ADDENDUM NO. 4  
TO THE  
DRAWINGS AND PROJECT MANUAL  
FOR  
**NEW OPPORTUNITY AWARENESS CENTER  
KATY INDEPENDENT SCHOOL DISTRICT  
KATY, TEXAS**

06/17/2026

#### CIVIL CONSULTANT, ADDENDUM No. 4

PROJECT NO.  
**25-0067.00**  
 SHEET TITLE  
**ELECTRICAL POWER LEVEL ONE FLOOR PLAN**  
 SHEET NO.

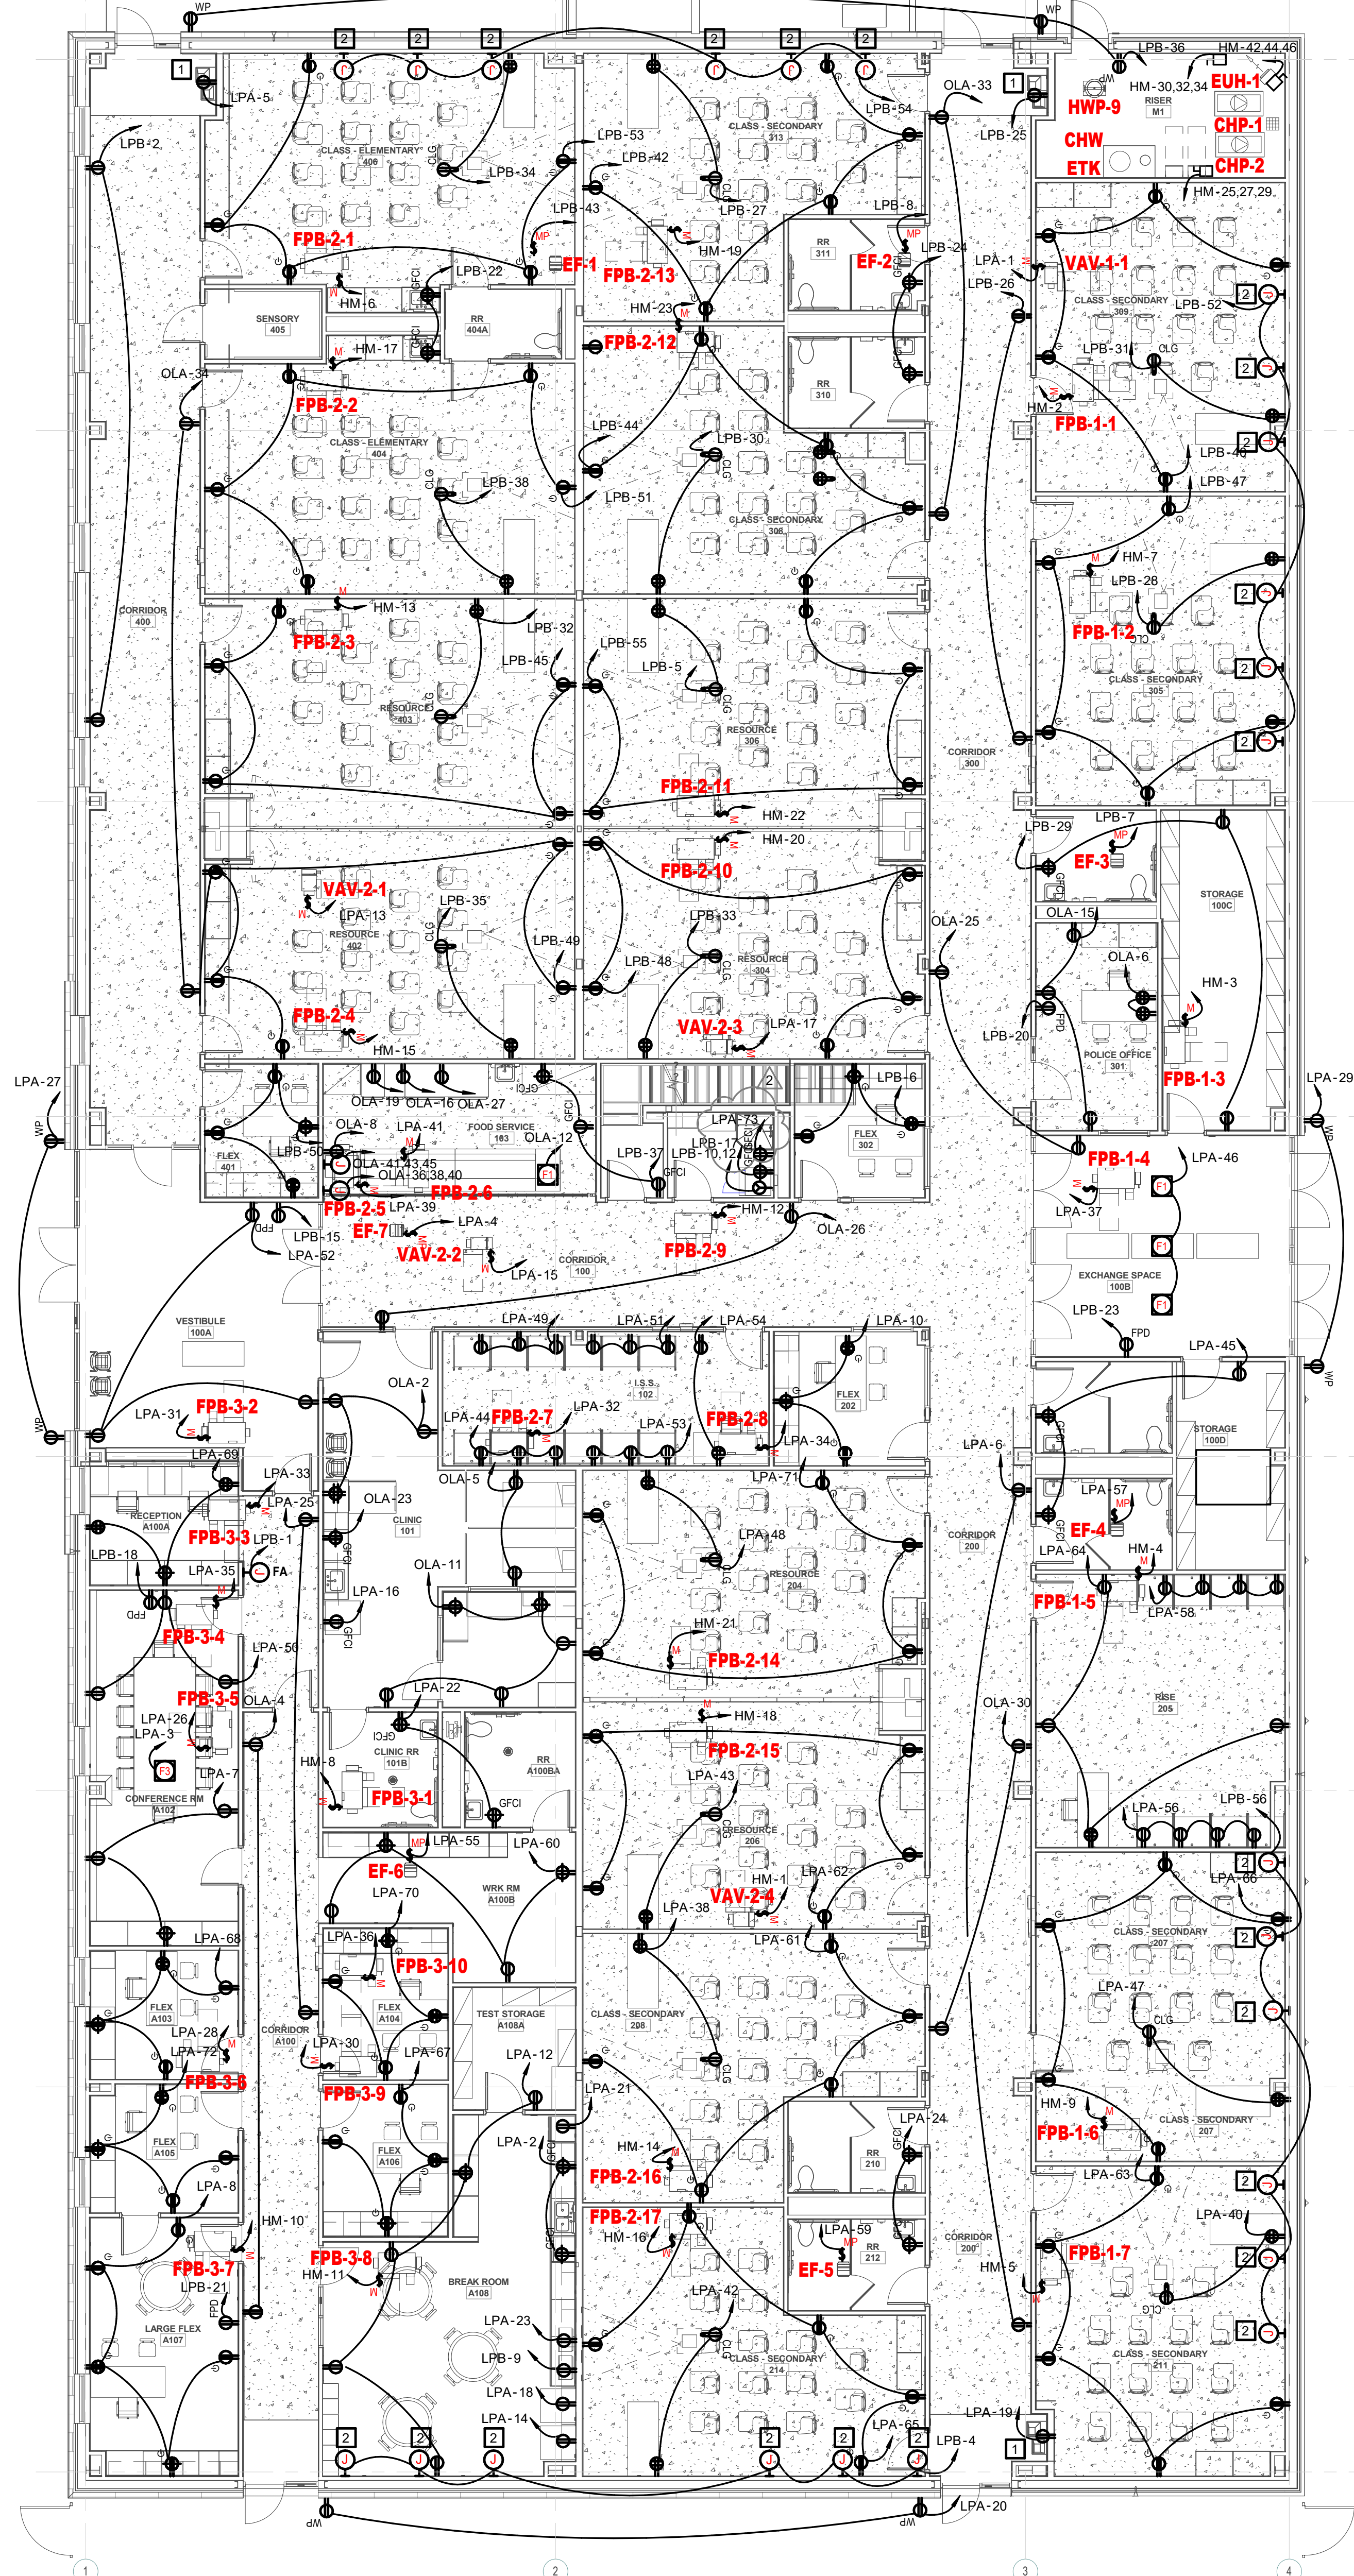
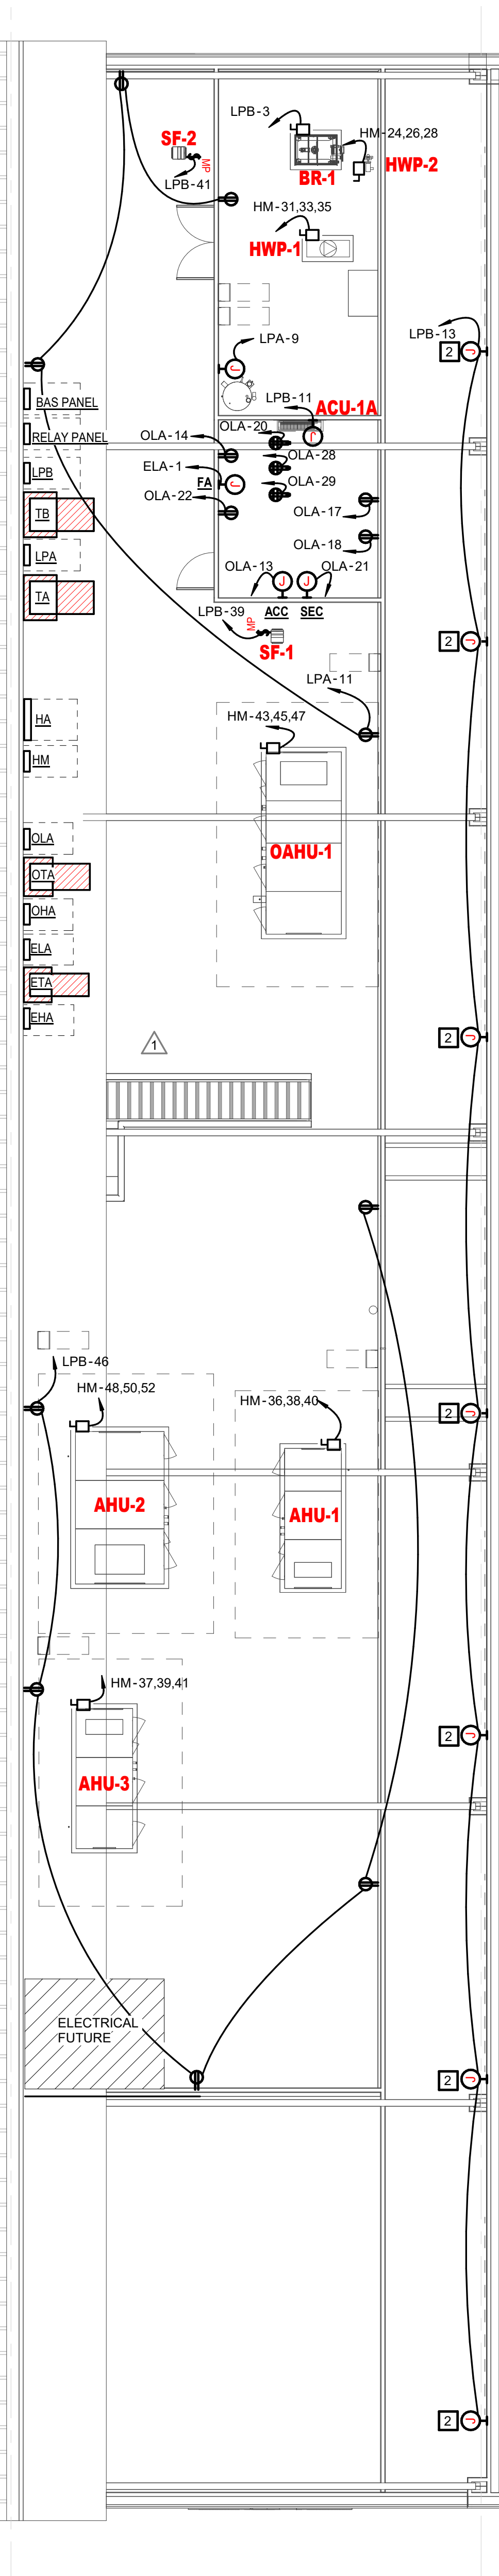
**6. SHEET E2.11 – POWER LEVEL ONE FLOOR PLAN**

- A. Added power for the boost fan.

1 TECHNOLOGY OVERALL SITE PLAN  
T1.11 1" = 20'-0"

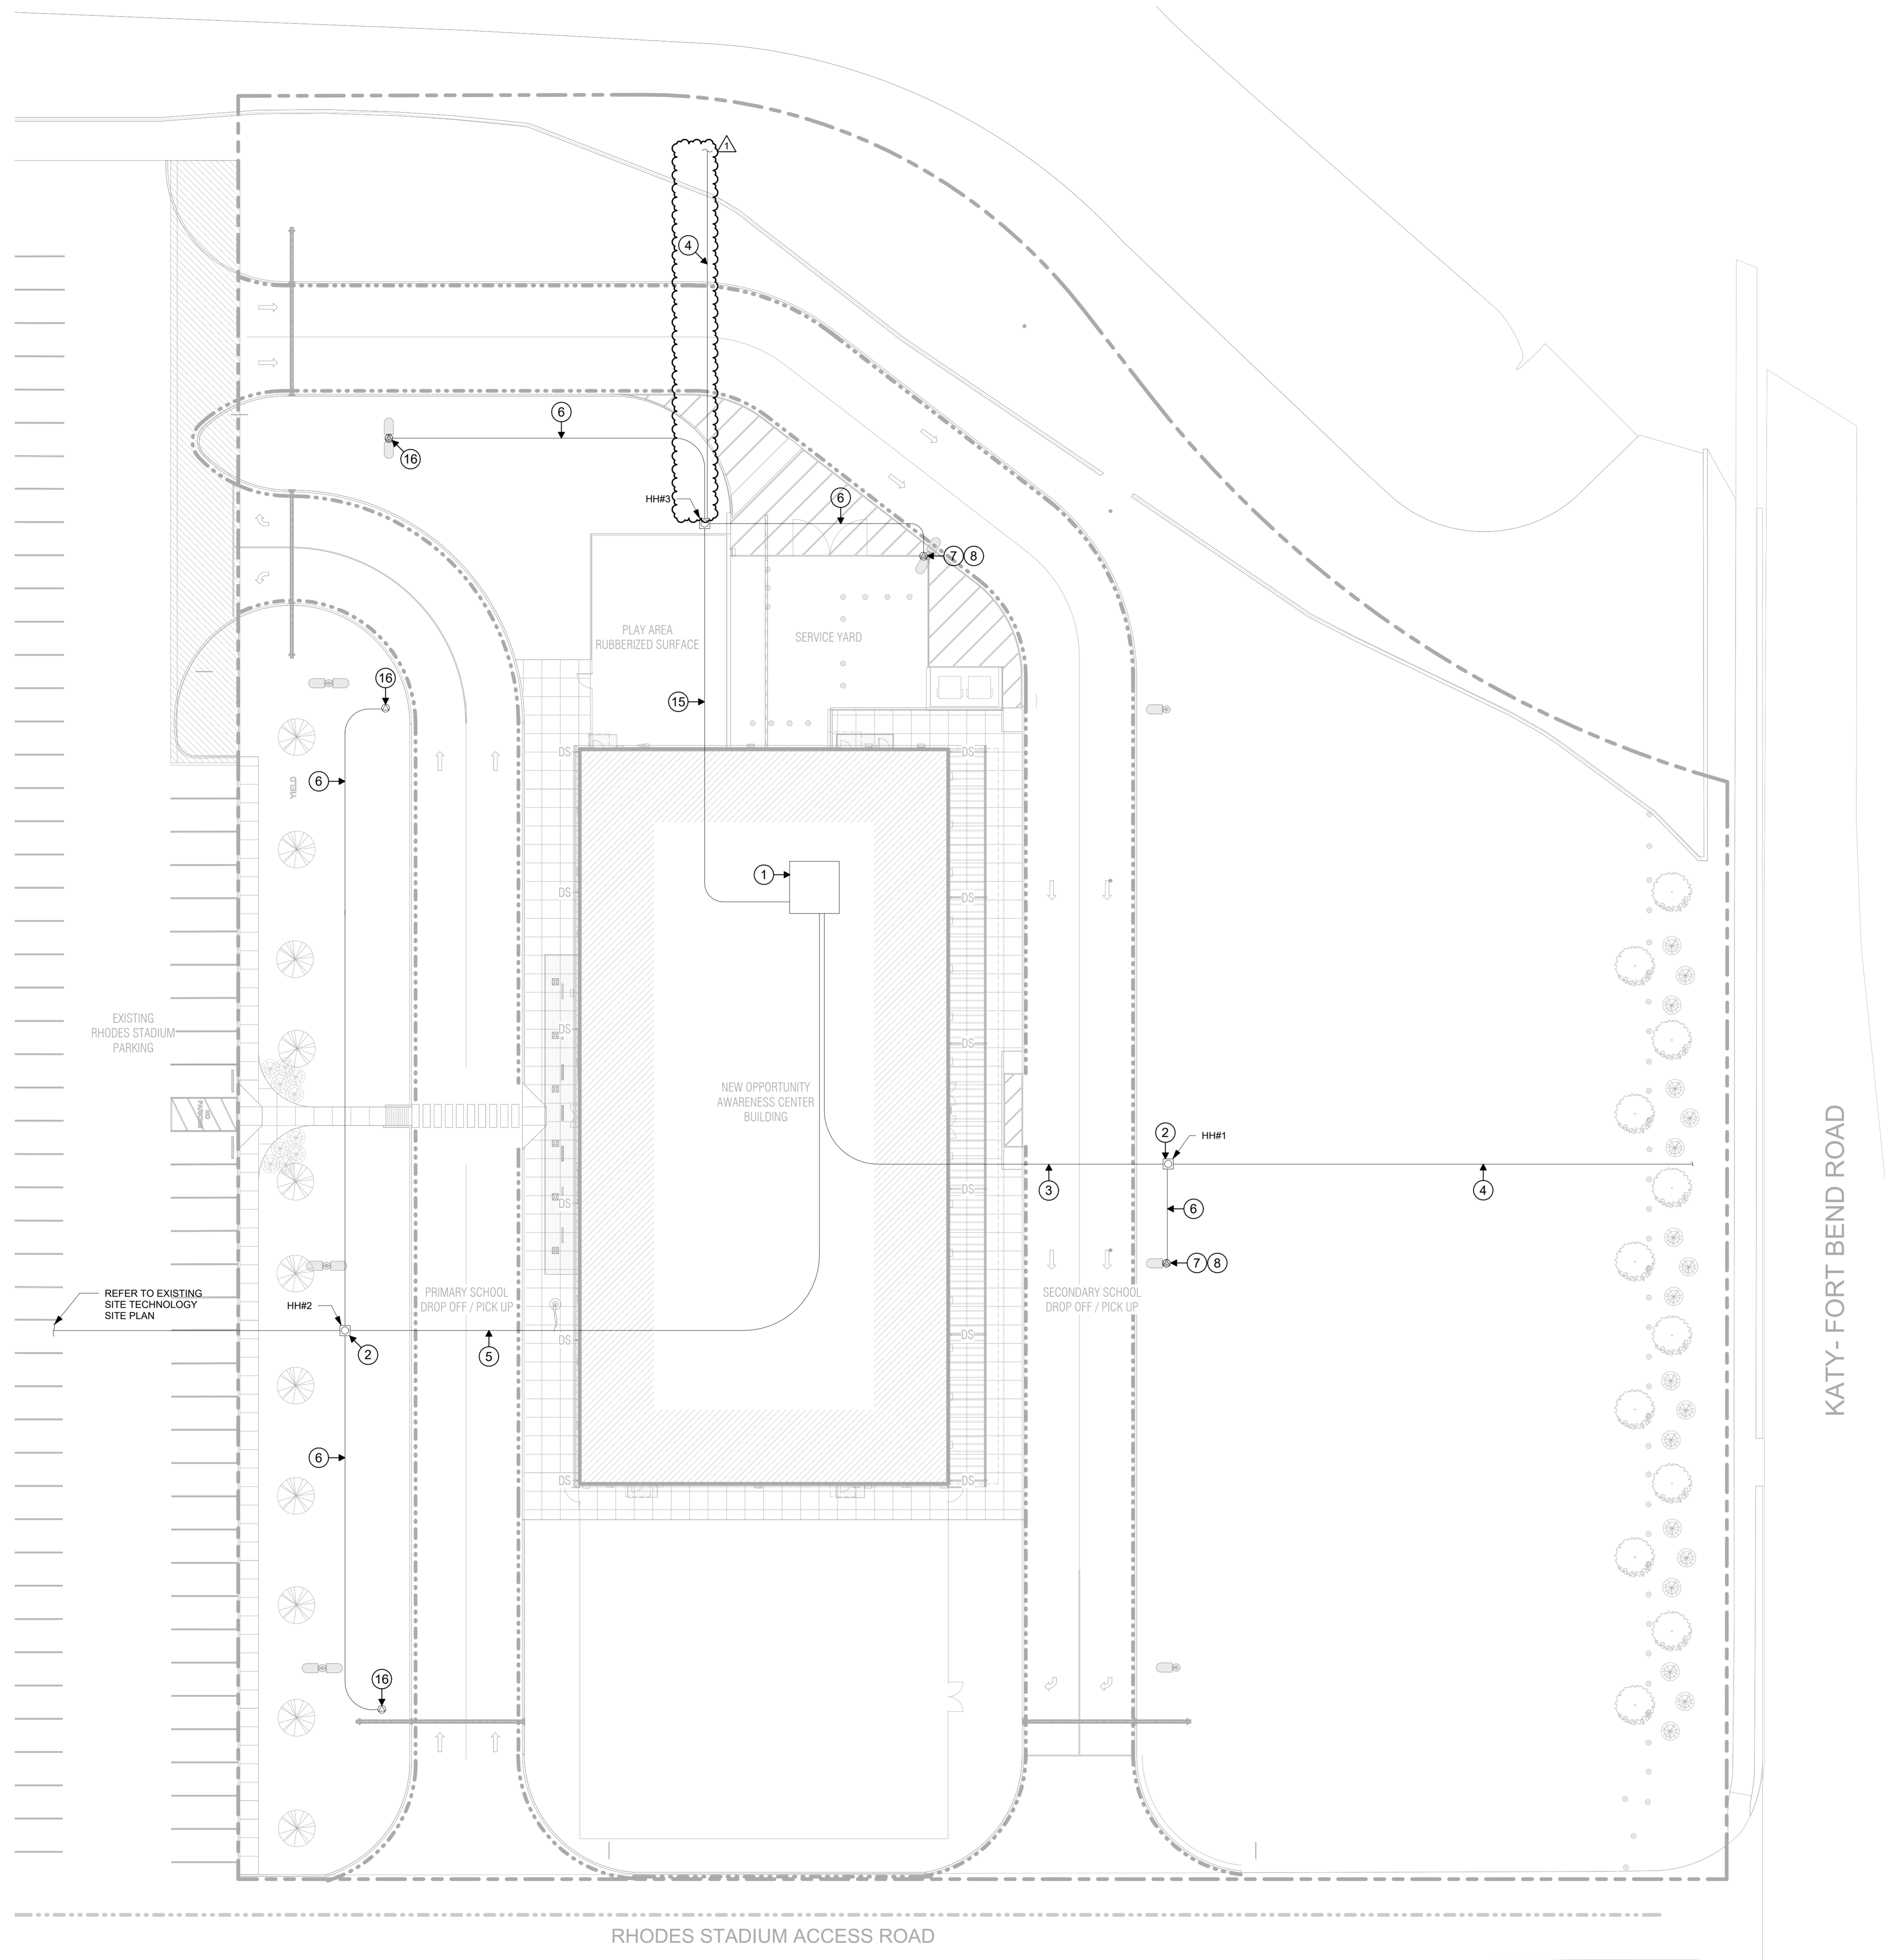
### 2. SHEET T1.11 – TECHNOLOGY OVERALL SITE PLAN

- A. Added infrastructure updates to the Technology Overall Site Plan. New pathway routing has been incorporated north of the building to provide a redundant service provider entry point and improve service continuity to the property line.
- B. Revised Keyed Note 15 to increase the pathway requirement from (2) 2-inch conduits to (2) 4-inch conduits to accommodate incoming service provider cabling and provide additional capacity for future expansion.
